**CLARK**  
Construction Company

## **ADDENDUM NO. 3**

**PROJECT:** Birmingham Public Schools 2015 Bond Program, Summer 2016

**CLARK PROJECT NO:** 15-2700

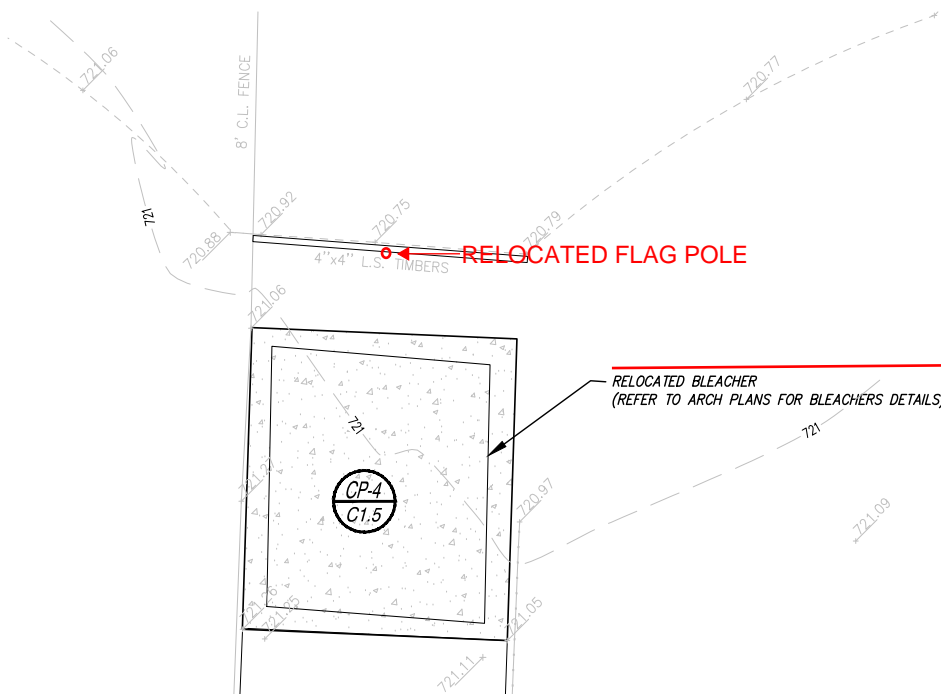
Groves- Sheet C1.4 indicates to relocate flag pole. Where does it get relocated to and what size foundation is required?

The flag pole will be relocated north of its current position, to a new location between the relocated bleachers on the new concrete pad, and the existing fence to the north of the pad. Distance from the first base line to the flag poll, to be maintained.

Foundation details and reinforcing to match existing.
